Item ID: D206-667-107BL
Revision ID:
Item Name: Crosstube Mid Fwd, Blue

DESIGN	GP	**DART AEROSPACE LTD** HAWKESBURY, ONTARIO, CANADA
DRAWN	GP	
CHECKED		DRAWING NO. D206-667-147 REV. A
MFG. APPR.		SHEET 1 OF 4
APPROVED		TITLE CROSSTUBE ASS'Y (206L MID FWD) SCALE N/S
DE APPR.		
DATE	10.12.23

DRAWING NO.	TITLE	REV. A	DART AEROSPACE LTD	D.E.O. NO.	SHEET NO.	SCALE
D206-667-147	CROSSTUBE ASS'Y (206L MID FWD)		ENGINEERING ORDER	D206-667-147-A-1	SHEET 1 OF 1	NTS

DRAWING NO.	TITLE	REV.	DART AEROSPACE LTD ENGINEERING ORDER	D.E.O. NO.	SHEET NO.	SCALE
D206-667-147	CROSSTUBE ASS'Y (206L MID FWD)	A		D206-667-147-A-2	SHEET 1 OF 1	NTS

C3-3 **DETAIL H**
SCALE 4X
(VIEW LOOKING FWD)

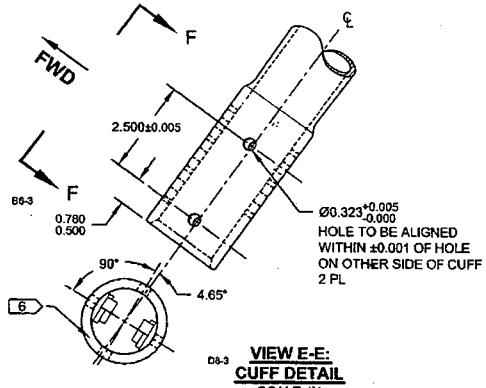
UNDER REVIEW
ECN #11-615
11.07.28

DEO ATTACHED

TURNING DETAIL

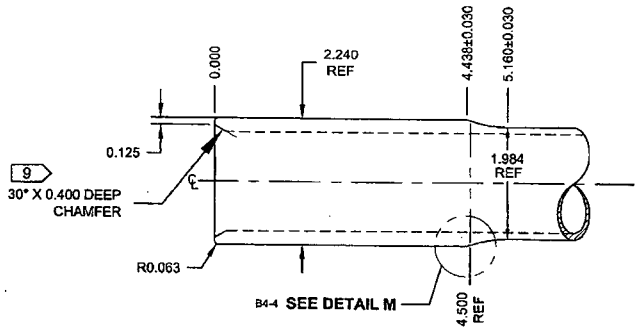
UNDER REVIEW
11.06.13
ECN # 11-615
11.07.28

DEO ATTACHED

DETAIL P
BONDING STRAP INSTALLATION 2 PL

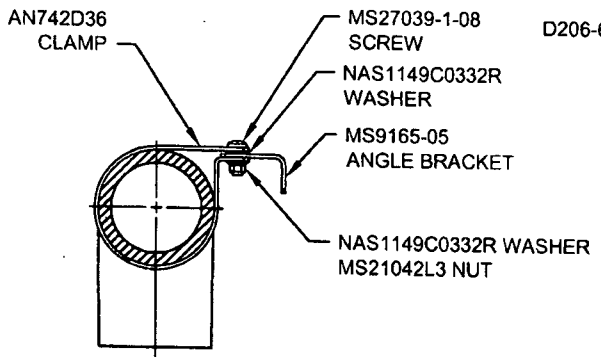
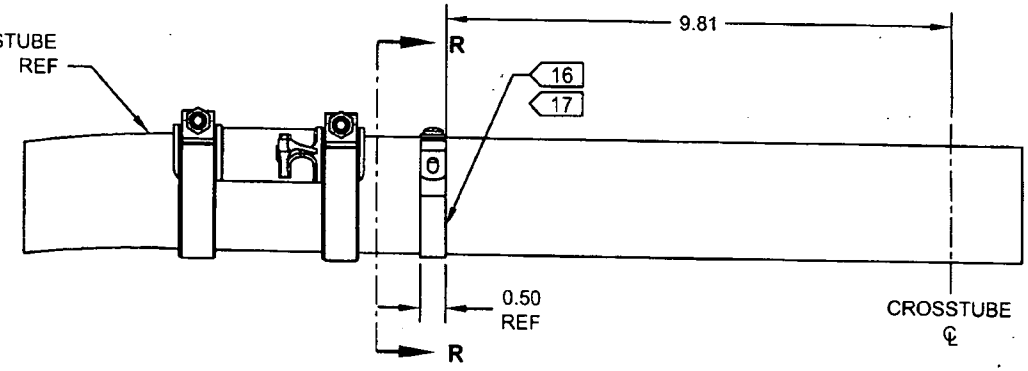
ADD ELECTRICAL GROUNDING STRAP

ITEM	QTY -147	PART NUMBER	DESCRIPTION	
1	X	D206-667-147	CROSSTUBE ASSEMBLY (206L MID FWD)	
10	2	AN742D36	CLAMP	ADD
11	2	MS9165-05	ANGLE BRACKET	
12	2	MS21042L3	NUT (OR MS21042-3)	
13	2	MS27039-1-08	SCREW	
14	4	NAS1149C0332R	WASHER (OR AN960C10L)

16) MASK AREA UNDER CLAMP PRIOR TO PAINTING
17) SEAL EDGES WHERE AN742D36 CLAMP MEETS WITH THE CROSSTUBE USING SIKAFLEX-241/-291 OR MIL-S-8802 CLASS B2 OR PROSEAL 890 SEALANT — ADD
18) PERFORM RESISTANCE CHECK TO ENSURE MAX RESISTANCE IS 10 MILLIOHMS

RELEASED
12.08.17
ECN 12-631
